# STATE OF NEW HAMPSHIRE

**SUBJECT** Application Amendment Request, RFMI Response, & Mixing Zone Request  
Lebanon-Hartford, 16148  
**(DES#2018-03001)**

**Lebanon, NH - Hartford, VT, 16148**  
**Mitigation Narrative**

**WETLAND PLANS**

STATE OF NEW HAMPSHIRE			
DEPARTMENT OF TRANSPORTATION • BUREAU OF HIGHWAY DESIGN			
<i>WETLAND PLAN 01</i>			
DGN	STATE PROJECT NO.	SHEET NO.	TOTAL SHEETS
16148genp1ans	16148	5	14

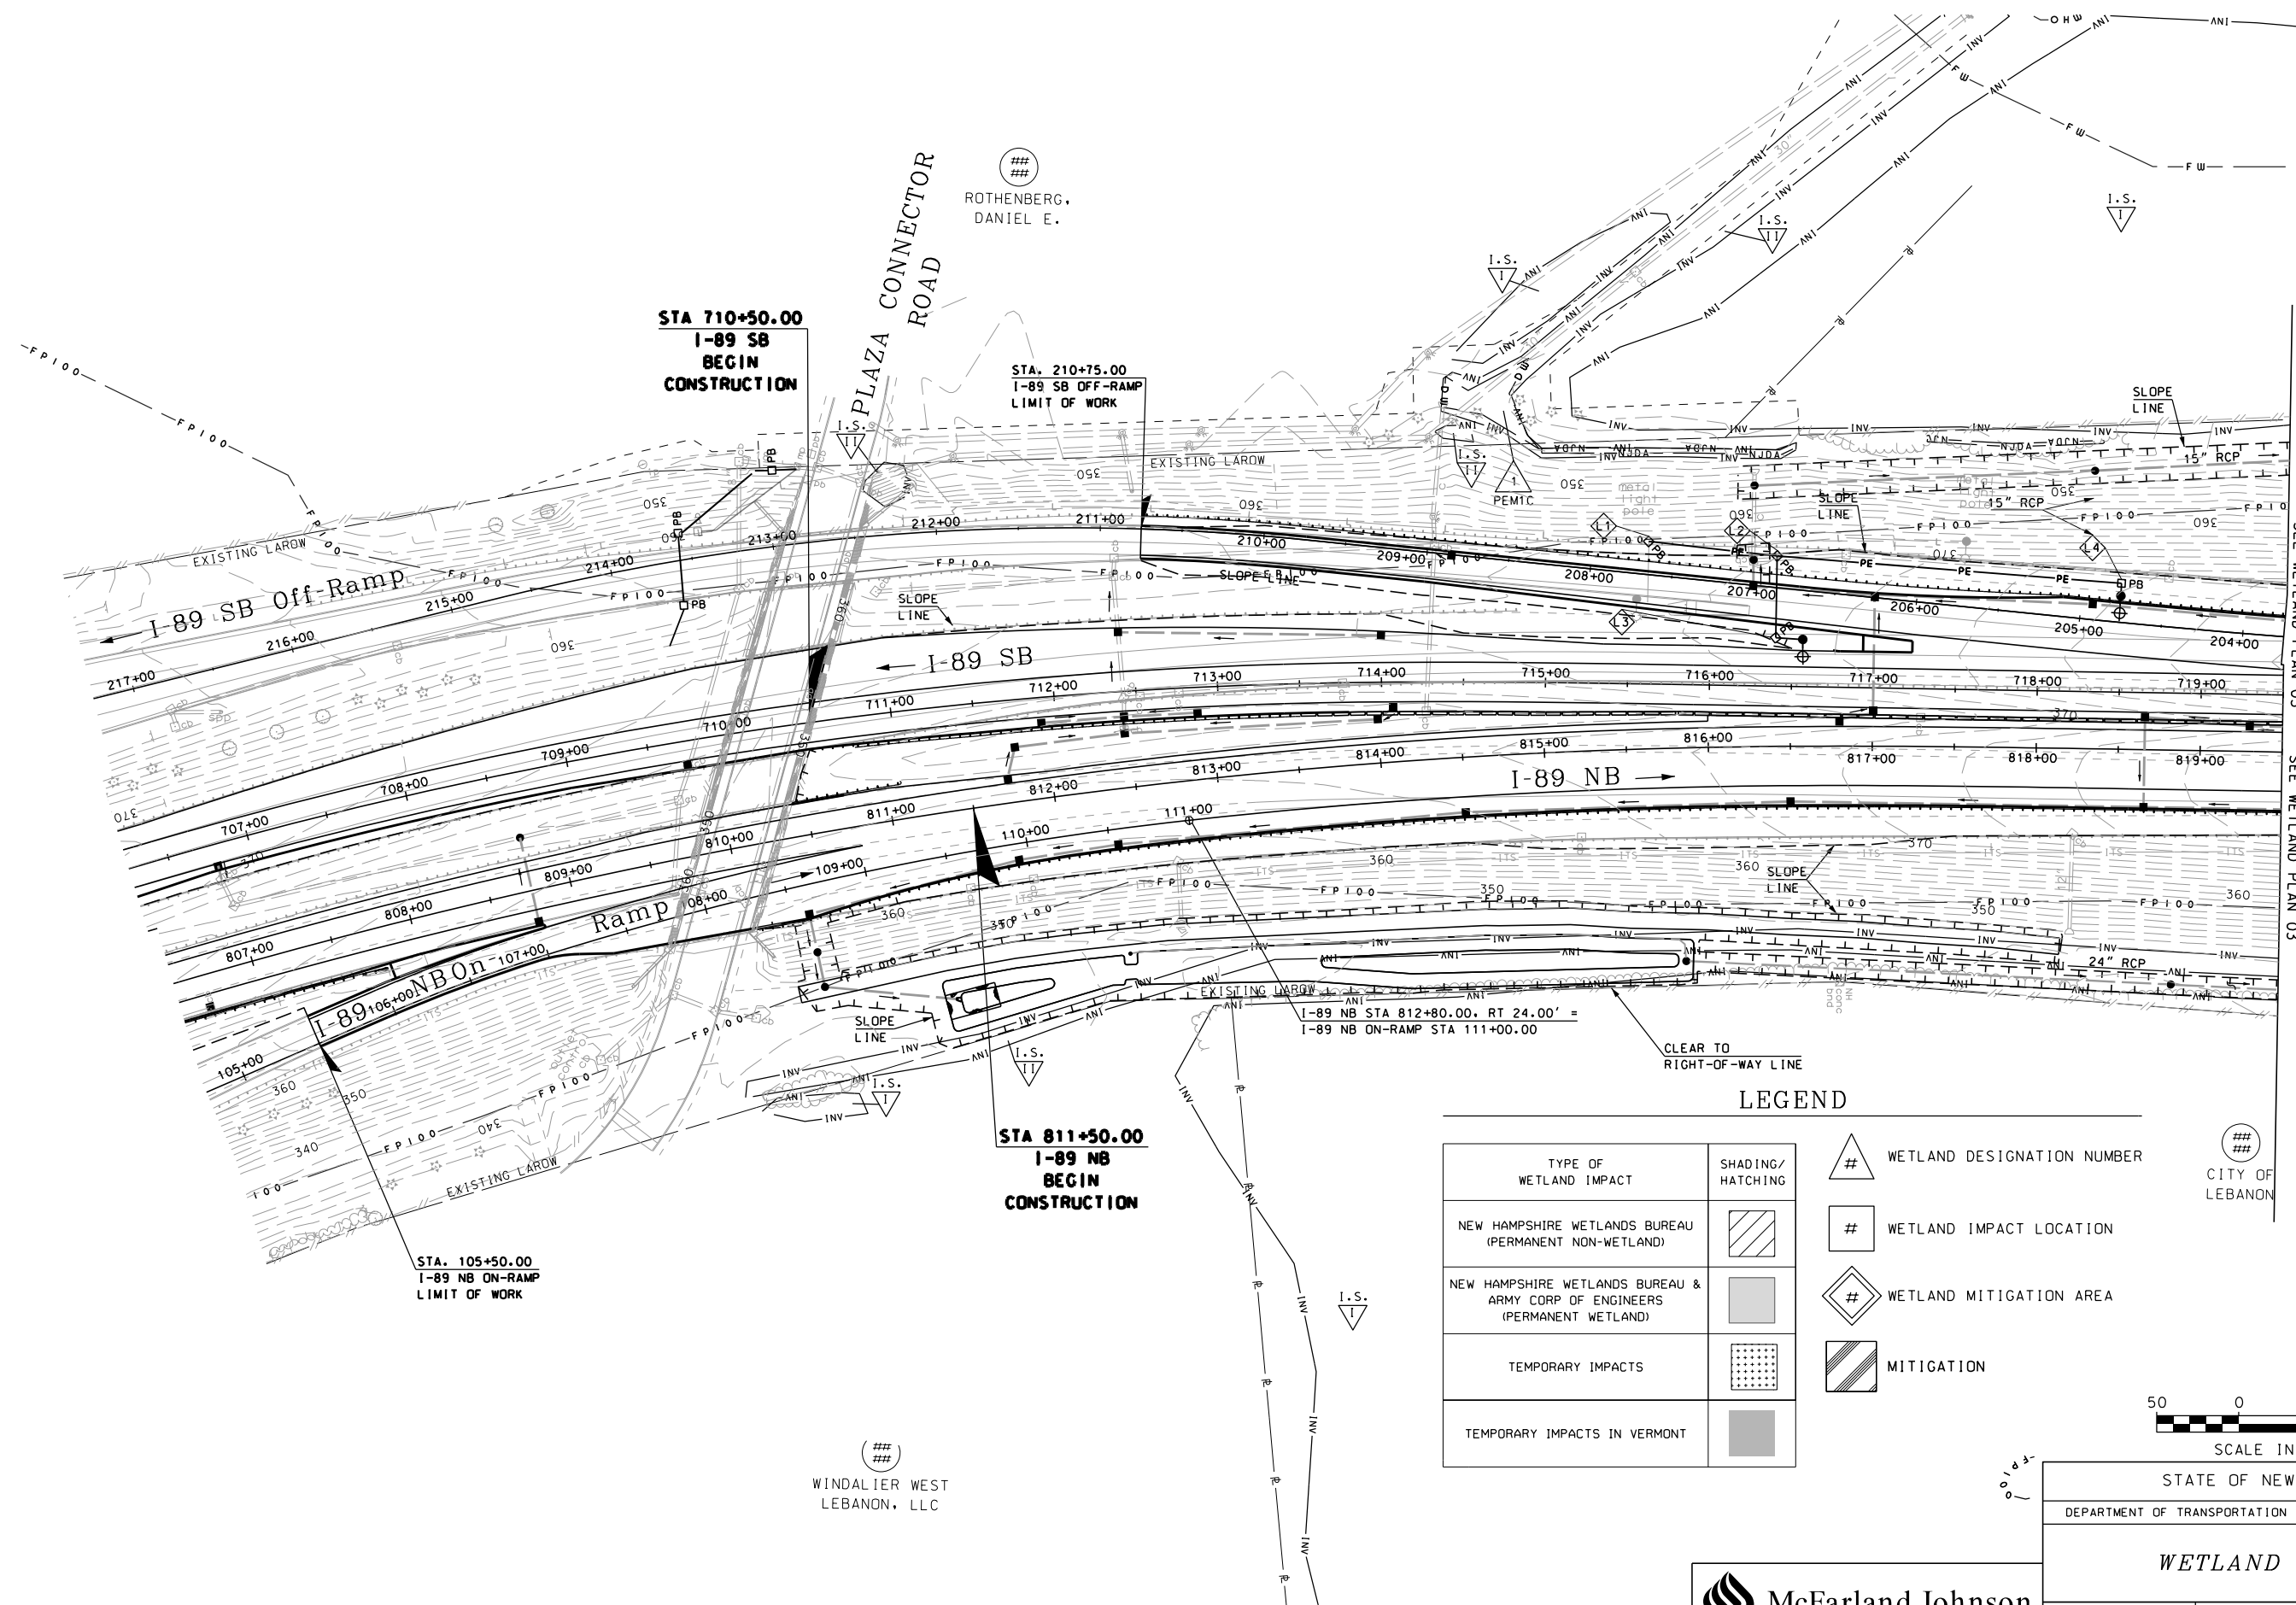
The enclosed wetland impact plans (Attachment #5) and construction sequence (Attachment #4) have been revised to reflect the project as now proposed.

\* ACTUAL IMPACTS WILL BE LIMITED TO TRESTLE PILES (APPROX. 600 SF)  
\*\* IMPACTS SHOWN IN BOLD TEXT HAVE BEEN REVISED

STATE OF NEW HAMPSHIRE			
DEPARTMENT OF TRANSPORTATION • BUREAU OF HIGHWAY DESIGN			
PRECAST CONCRETE REVTMENT DETAILS			
DGN	STATE PROJECT NO.	SHEET NO.	TOTAL SHEETS
16148pcnrvdt.dgn	16148	11	14

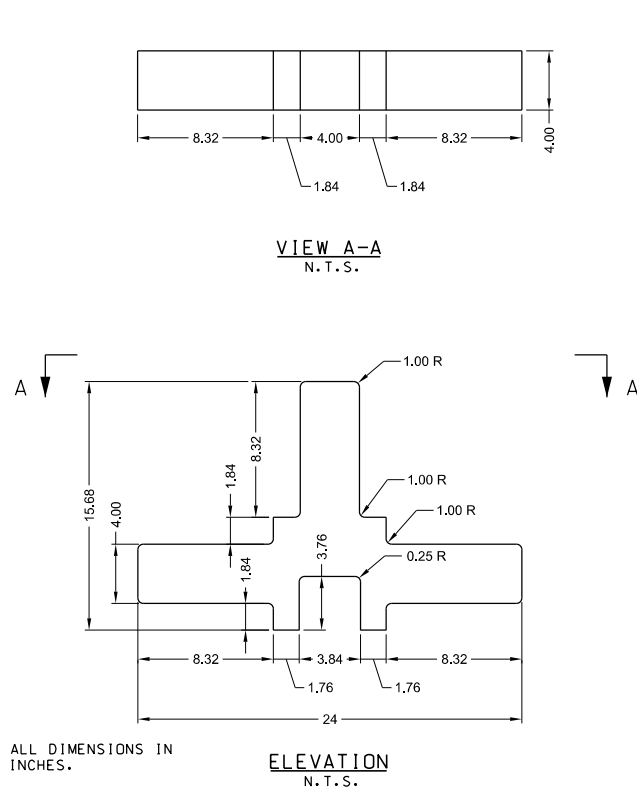
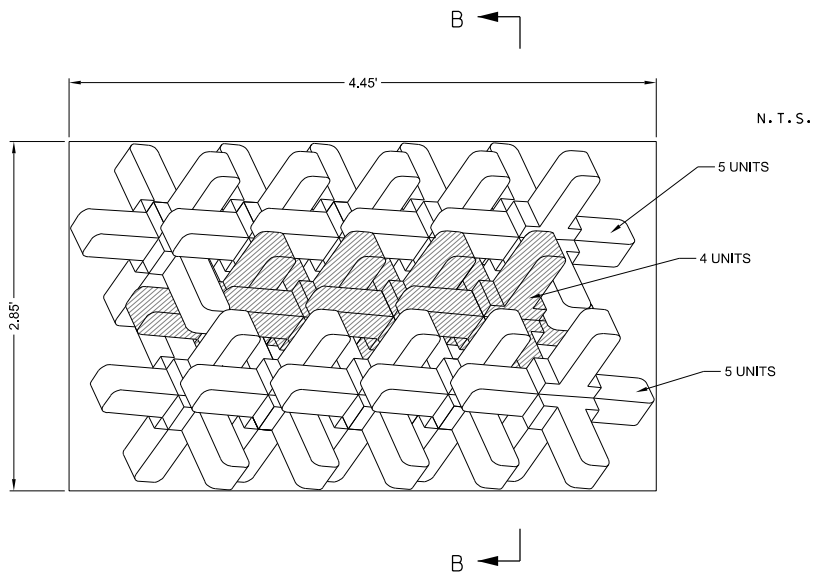
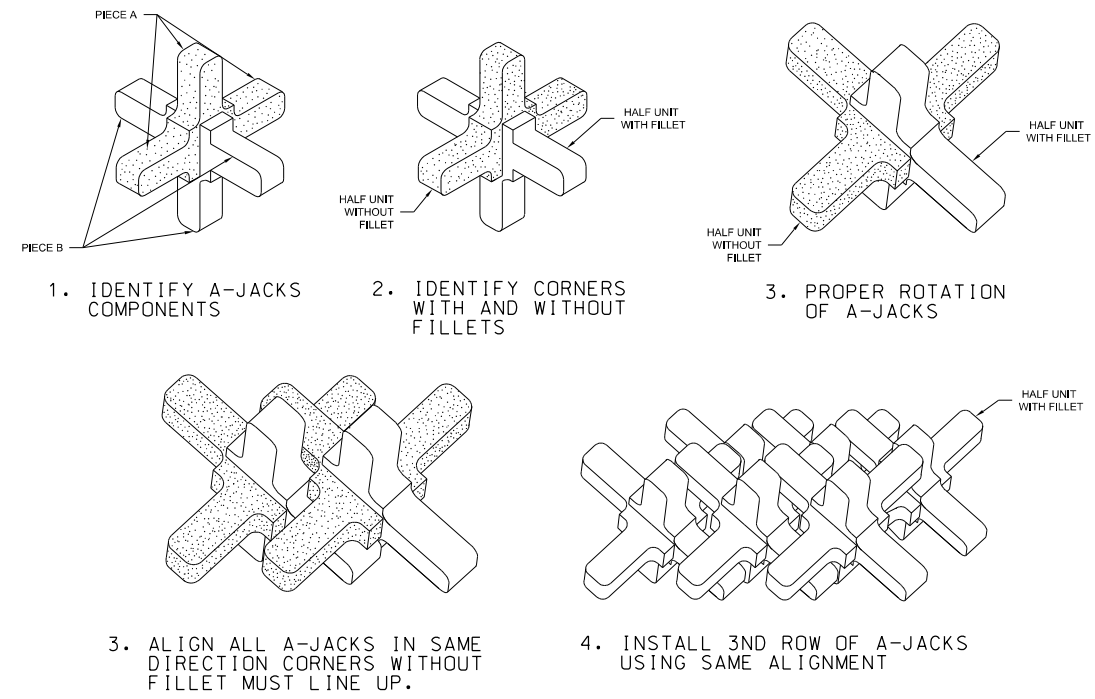
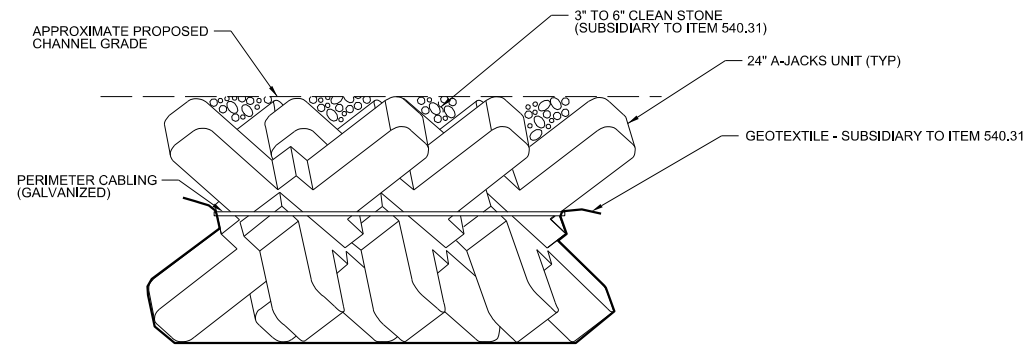
An application amendment is requested to account for embedding the proposed A-Jacks scour protection, adding stone across the top of the A-Jacks, and extending the scour protection an additional 5 feet downstream. The extension of the scour protection footprint was determined to be necessary after further analysis of scour potential. Embedding the A-Jacks and adding stone across the top of the A-Jacks is now proposed in order to eliminate the proposed Vermont bank cut and still avoid an increase in base flood elevation. Additional information regarding this change is provided in the enclosed summary of floodway considerations (Attachment #1).

- 7) **Pier Scour Protection:** Additional details of the proposed A-Jacks are now included in the enclosed wetland impact plans. As discussed above, a decision was made to embed the A-Jacks in lieu of the originally proposed VT bank cut in order to eliminate the increase in base flood elevation. The A-Jacks will not impede river flows or hinder any in-water recreational activities.
